BAR Meeting
July 21, 2010

ISSUE: Permit to Demolish/Encapsulate and Addition/Alterations
APPLICANT: James M. & Misty L. Dameron
LOCATION: 603 South Saint Asaph Street
ZONE: RM / Residential

Photo showing the view from Gibbon Street

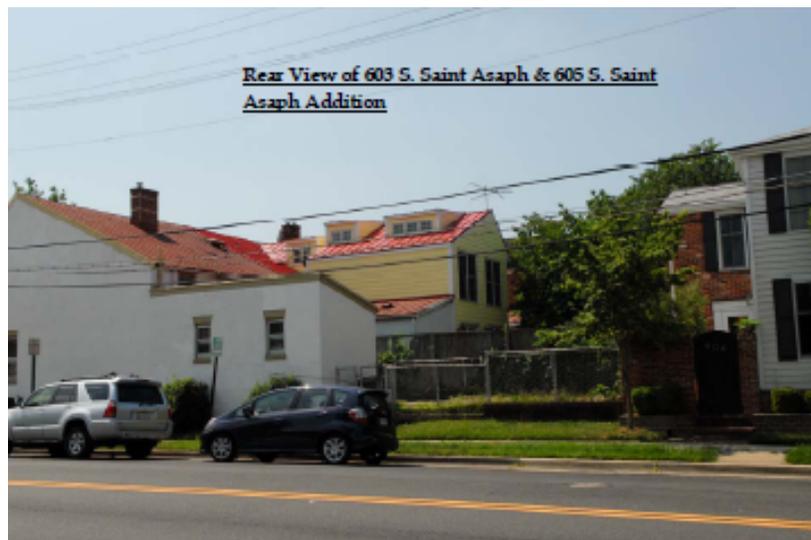
The construction of an addition to any building within a historic district must be evaluated not only for its impact on the building to which it is being attached, but also for its impact on the district as a whole. The *Design Guidelines* encourage “designs that are respectful of the existing structure and which seek to be background statements or which echo the design elements of the existing structure.” The rear addition is not visible from South Saint Asaph but will be highly visible from the north on Gibbon Street. There is no alley. An addition of similar scale was approved next door at 605 South Saint Asaph Street by the BAR on the consent docket on July 20, 2005.

Original Submission North Elevation

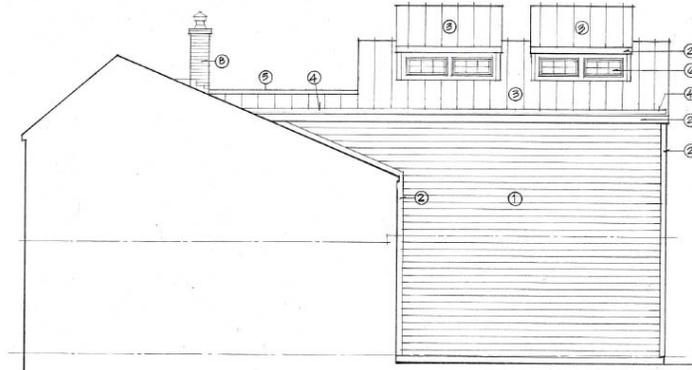
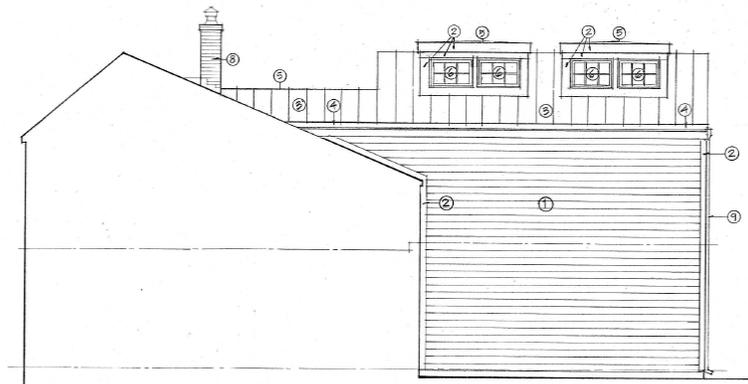
Staff asked the applicant to restudy the original submission because the roof of the proposed addition was significantly higher than the ridge of the historic home, as shown below.

As the revised drawings illustrate, the lower addition roof now proposed will clearly read as an addition but is more compatible in scale with the existing building. The proposed gable roof form has a flat roof area that acts as a hyphen before intersecting the gable of the historic block. The use of flat roofed monitors breaks up the mass of the rear addition while also providing interior light at less overall height than the previously proposed dormers.
